DIABLO CANYON INDEPENDENT SAFETY COMMITTEE

August 6, 2024

Thank you for your prompt reply in your letter on July 19 to our letter of June 28, 2024 asking certain questions regarding your June 14, 2024 report entitled: "Technical Evaluation of Reports by Dr. Mark Kirk Regarding the Condition of Diablo Canyon Unit 1 Pressure Vessel" (see Appendix). Your responses help us by explaining your understanding of the degree of embrittlement of the reactor pressure vessel and other issues you raise. This letter responds to your answers to our questions and to clarify our position as explained in Dr. Kirk's two reports.

Figure 1. Corrected Figure 1 from June 14 Technical Report.

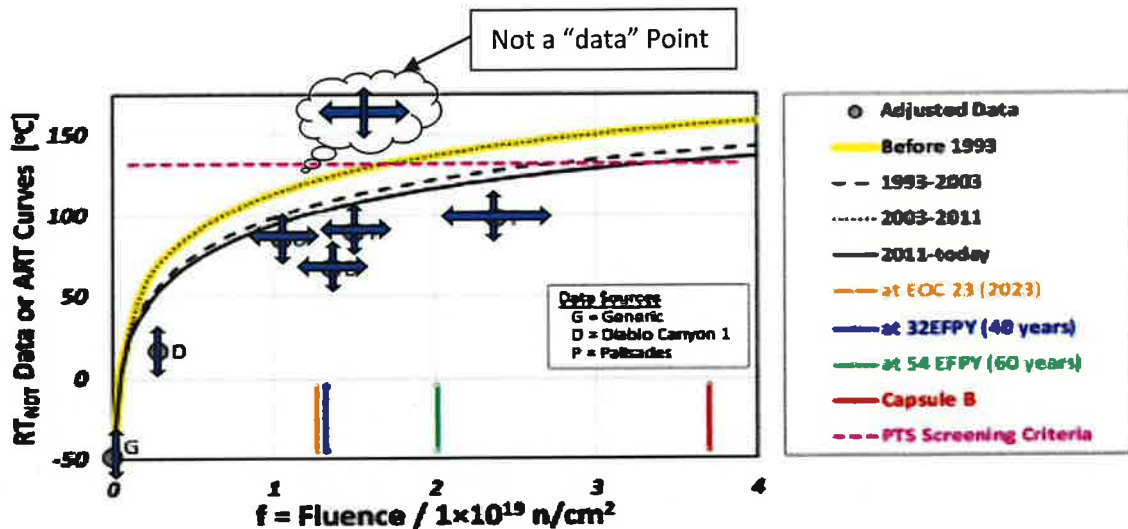
Your corrected graph showing calculated bands of uncertainty and clarifies your position. You stated in your reply that the fluence uncertainty corresponds to ± 14 -20% (a value you got from WCAP-15958) and the ART uncertainty corresponds to $\pm 1\sigma$ where the σ values were reported in NUREG/CR-6551. However, you continue to show a data point that is not a measurement from Palisades but is a predicted value from an NRC document published in the 1980s. You stated that the ART value associated with this point of 161 °C can be found in ADAMS ML102310298. We cannot determine the fluence value for this point, but assume it corresponds to the Palisades fluence in 2007, as stated in Table 3 of ADAMS ML102310298. Finally, we have been unable to determine why you also attribute this point to a citation called "Kirk, RG 1.99, Rev. 2." We cannot locate this citation.

The NRC's procedures require that only measured values be used in the type of evaluation shown in Figure 1. The measurements (dots) are fitted with the curves to determine the fluence at which the vessel is forecast to exceed the PTS screening criteria. We should also point out that the Chemistry Factor is estimated as either a best-fit for credible data or as an over-estimate for not credible data. The Chemistry Factor is a fitting parameter, not a physical property, as applied in this procedure. The Margin values also depend on data credibility, larger for not credible data and smaller for credible data. As your curves show, if the data is not credible, the yellow highlighted line reflects the added margin applied when assessing the plant's proximity to the PTS screening criteria. When the data is "credible," lower margins are permitted by the NRC as shown by the two black curves. Thus, if only measured values are used in the analysis (1 datum before irradiation and 5 data after irradiation from surveillance capsules), the PTS screening criteria will be reached at about 3×10^{19} n/cm², which is well beyond fluence of 2×10^{19} n/cm² associated with 60 years of operation.

You also point out that one data point shows a lower value of ART at a higher fluence than the previous data point, but the difference between these values is within the uncertainty bounds that you calculated.

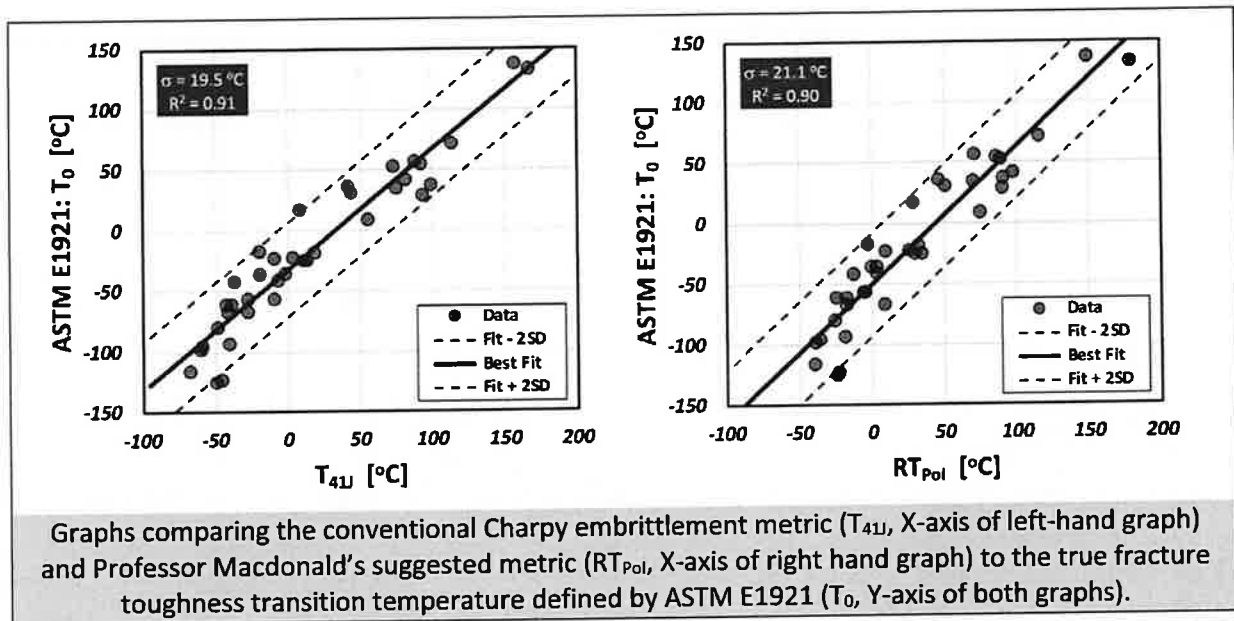
You also suggested that Dr. Kirk perform his analysis using the RT_{Pol} . We have performed two analyses to assess the RT_{Pol} approach. The upper pair of graphs shown below compare both the traditional (T_{41J}) and proposed (RT_{Pol}) Charpy embrittlement metrics to the true fracture toughness transition temperature (T_0), which any Charpy metric seeks to estimate (data used here are from RPV steels¹). The predictive capability of both T_{41J} and RT_{Pol} are similar, with the latter proposal offering no advantage over the traditional (and required) approach.

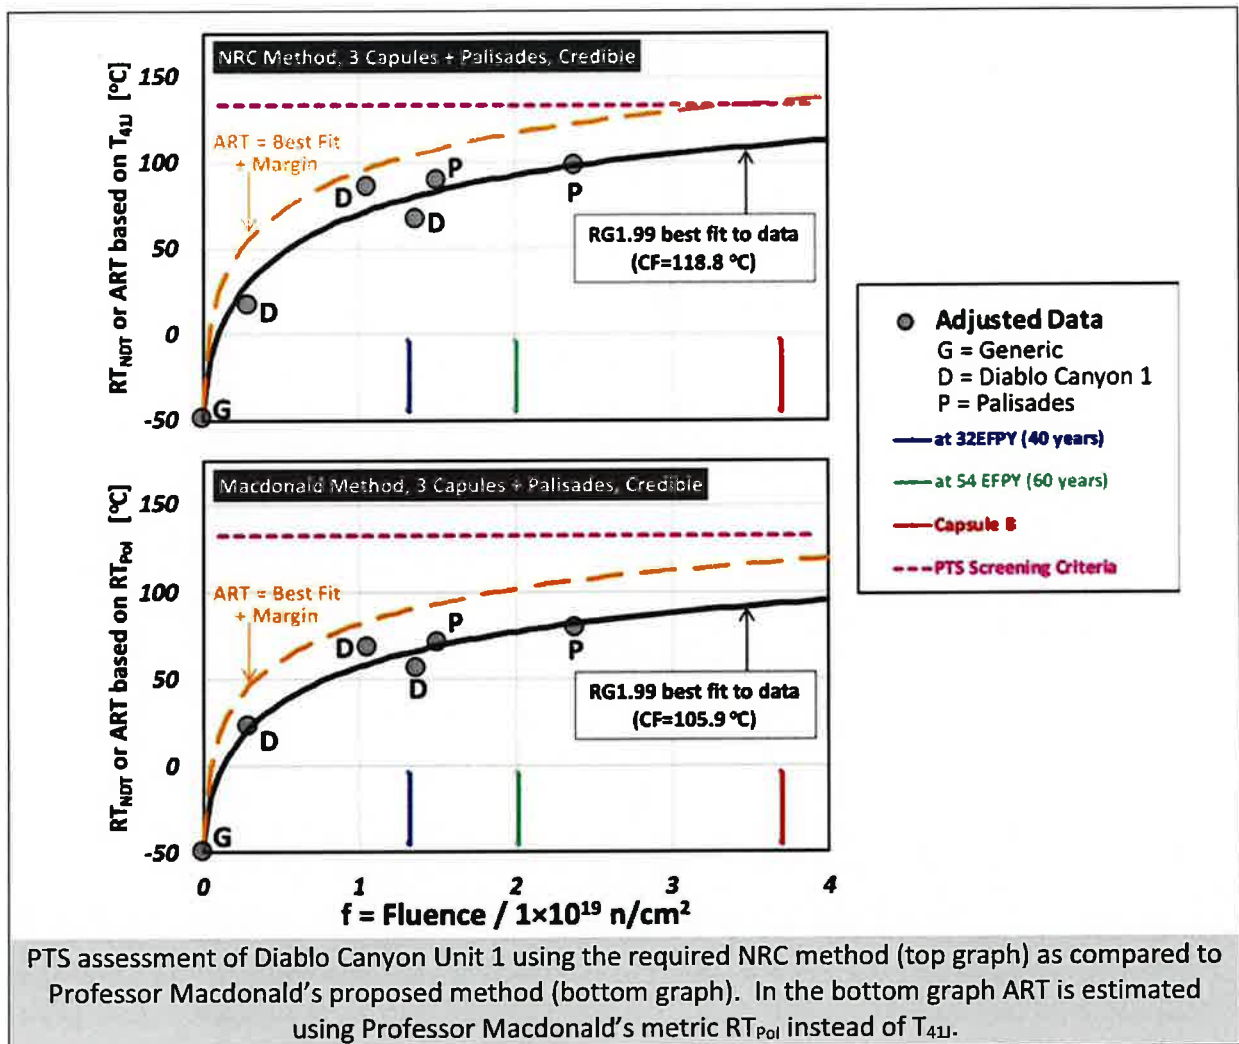
Secondly, we have used both T_{41J} and RT_{pol} to perform a PTS assessment of Diablo Canyon Unit 1 using a data set comprised of a generic unirradiated value of RT_{NDT} , three surveillance data from Diablo Canyon Unit 1, and two surveillance data collected on the same weld wire heat as part of the Palisades surveillance program. This pair of graphs compare the traditional/required approach on the upper plot with Professor Macdonald's recommended approach on the lower plot. On the lower plot the transition temperature shift is calculated as the increase in RT_{pol} between the unirradiated state and the various irradiated measurements.

For this particular set of data for the weld wire heat 27204, the increase in RT_{Pol} produced by irradiation is somewhat lower (12 °C on average over the five irradiated measurements) than the increase in T_{41J}. As illustrated on the figure, this lower degree of embrittlement forecast by the RT_{Pol} approach reduces the estimated value of the chemistry factor and increases the fluence at which Diablo Canyon Unit 1 is predicted to exceed the NRC's PTS screening criteria (this fluence is determined by the intersection of the orange ART curve with the horizontal magenta line). Nevertheless, both the NRC's approach as well as Professor Macdonald's approach reach the same conclusion: based on all currently available data, Diablo Canyon Unit 1 is not expected to exceed the NRC's PTS screening criteria until it reaches a fluence far in excess of the fluence associated with 60 years of service.

Figure 1. Corrected Figure 1 from June 14 Technical Report.

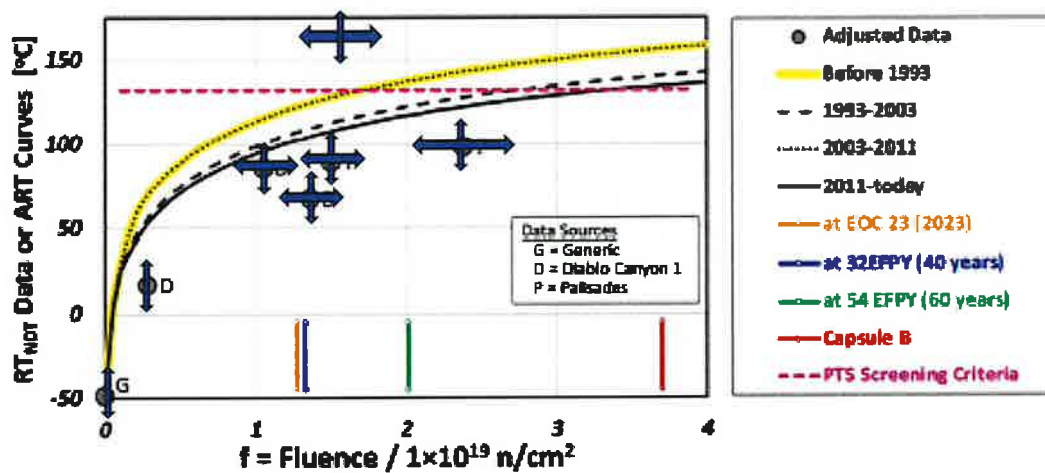
- a. Please provide data sources for each datum plotted as well as the underlying properties (copper content, nickel content, unirradiated RT_{NDT} , measured ΔT_{41J} , plant of origin, fluence, irradiation temperature). Please also describe the basis for uncertainty bands for both fluence and ART.**

- c. Please explain the basis for the uncertainty bands shown in your figure. Also, please clarify whether the plotted uncertainty bands represent one standard deviation or some other measure.

- d. Embrittlement data typically show a leveling off of the increase of ART with increasing fluence. Your figure shows a straight line. Was the line in your plot fit using the method of least squares, or by some other method? Also, please describe the basis for assuming that the variation of ART with fluence is linear for the Diablo Canyon Unit 1 weld.

Embarrassingly, the plot in my report contained an inadvertent error, when I plotted the error bars in °F on the °C scale employed by Dr. Kirk. Note that °F scale is normally used for expressing ART_{NDT} . The plot has been redone to correct the error. See Figure 1 below.

In addition, for clarity, the horizontal error bar has been omitted from Capsule S as its magnitude is barely more significant than the diameter of the data point. In this context, I would note that no physico-chemical measurement or theoretical prediction can be made with infinite accuracy. All experimental and theoretical calculations have associated uncertainties, commonly expressed as error bars in the three Cartesian coordinates (x, y, and z) or two Cartesian coordinates (x and y) for a planar plot. The error bars for the data from Capsule S have been superimposed on a plot taken from Kirk (Vol. 2) in Figure 1 below.

In the corrected Figure 1 above, no attempt was made to perform a “least squares” fit of a linear function to the data simply because the uncertainty in the data does not warrant such an analysis. The non-linear function represented by the solid line is probably the best fit that can be made, but there are possibly many “embrittlement trend correlations (ETC)” that could fit the data equally well.

Figure 2. Configuration of baffle former bolts in a Westinghouse-designed PWR that frequently fail by HIC. [NRC (2012)]. Details of the bolts are given immediately following this caption, as follows:

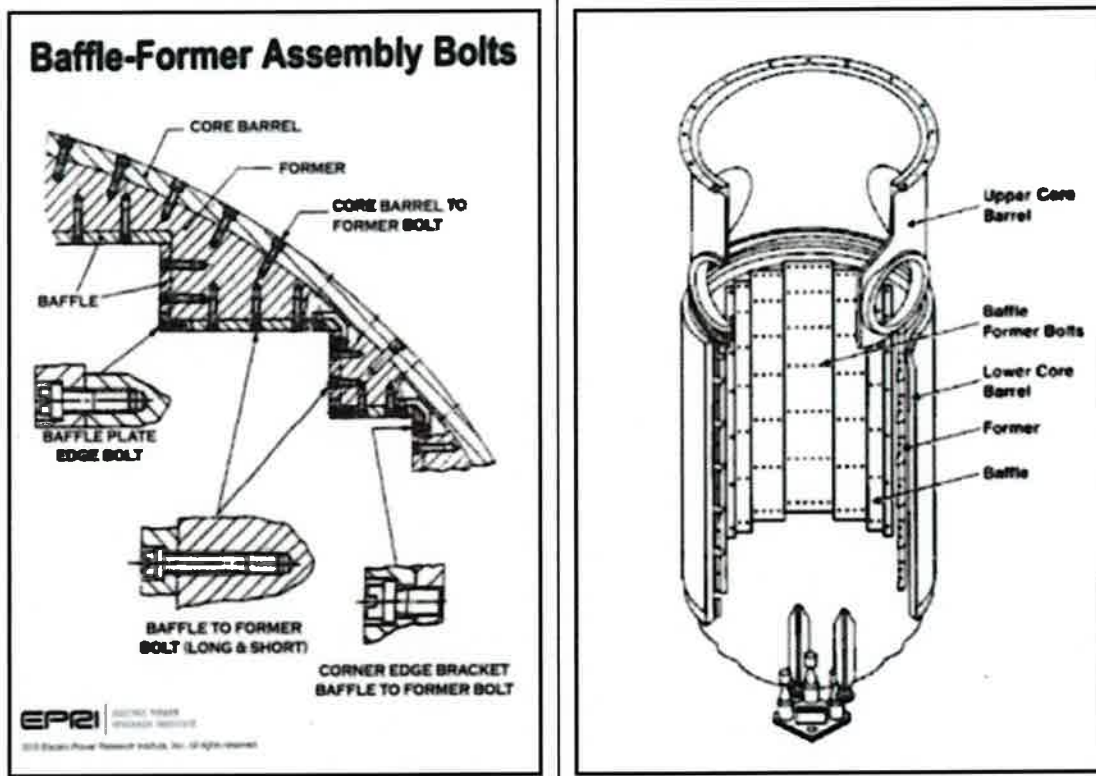
b. Please show evidence that the Unit 1 reactor pressure vessel contains cold worked 316L stainless steel, alloy 600, or alloy 182.

Another example of HIC is the failure of high-strength, baffle former bolts, as shown in Figure 2 below.

Typical baffle-former bolts are typically made of cold-worked stainless steel (Type 347, Type 316, or Type 304), are approximately 5/8ths of an inch in diameter, and are typically 1.5 to 2 inches long. Units that have replaced baffle-former bolts have done so in accordance with a Westinghouse-approved design that uses bolts with less susceptible material properties and an improved head geometry to reduce stress concentrations. Bolts made from Type 316 stainless steel are less susceptible to degradation than those made from Type 347 stainless steel. Most baffle-former bolt designs secure the bolt heads with a welded lock tab . . . These lock tabs normally retain the bolt heads should they become detached.

Figure 3. Schematic of the structure of the RPV of a WWER 440 Pressurized Water Reactor [Toribio et.al (2016)].

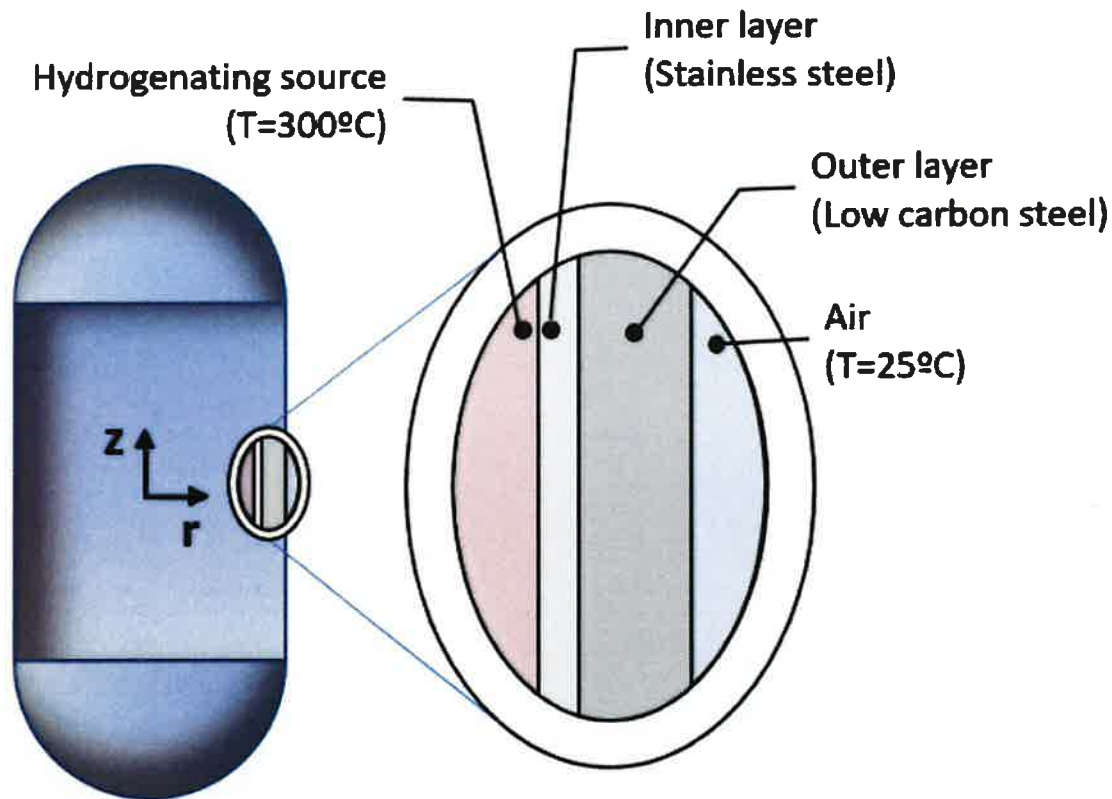
In your letter you state that Kuleshova paper confirms that the RPV of the VVER reactor pressure vessel comprises of SA508 Grade 3 Class 1 low alloy steel which is comparable to western PWRs. When comparisons are made of Soviet VVER reactor vessels, it is quite clear that they are radically different from what Diablo Canyon plate (A533 B Class 1) is made of as shown on the table² below. Thus, they provide no useful information on embrittlement of Diablo Canyon.

See Figure 3 below.

Figure IV.1. Graphs presented by Dr. Kirk support his assertion that my approach to calculating the embrittlement parameters is inferior to his (from (Kirk Report (2024)), Part 2, p. 57).

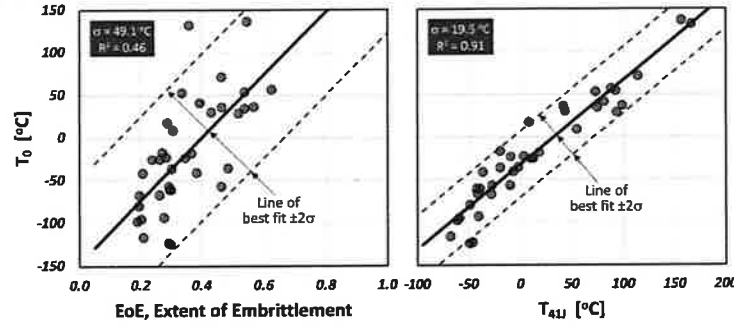
In his "Figure 28," reproduced below (Figure IV.1), Dr. Kirk presents two graphs showing that my approach is wrong or inferior. He makes this determination from the wider scatter band of the data shown in Figure IV.1, but that impression can be corrected by simply changing the scale on the vertical axis. Furthermore, the parameter that should have been plotted is $RT_{NDT,Pol}$ compared with T_{41J} rather than the extent of embrittlement (EoE), a derived quantity with no equivalence in Dr. Kirk's formulation. That would have allowed him to make a legitimate link to Fracture Toughness through his T_0 . He may not have appreciated that my T_0 ($RT_{NDT,Pol}$) is not the same quantity as his.

As the reader can note, in Figure IV.1, the comparison is between two different curves; on the left side, it is a curve of T_0 (units of degrees) versus EoE , while the right frame presents a plot of his T_0 (not indicated, we assume it is this one) versus T_{41J} (units of °C). The reader will note that for a comparison of the left and right frames to be valid, the axes on both frames must be the same. They are not, as the EoE is a dimensionless quantity. Furthermore, the reader will note that his analysis involves the extra parameter, T_0 , which is the fracture toughness transition temperature as defined by T_{41J} .

This parameter is not considered in my analysis. Instead, I use the temperature at the point of inflection of the hyperbolic tangent ($RT_{NDT,Pol}$), as derived by PG&E and Westinghouse (Capsule V Report (2003)). Comparing the two graphs is not an "apples-to-apples" comparison; rather, it is better classified as an "apples-to-oranges" comparison. A fair comparison would be to simply replace T_{41J} in the analysis with $RT_{NDT,Pol}$, and replot Figure IV.1.
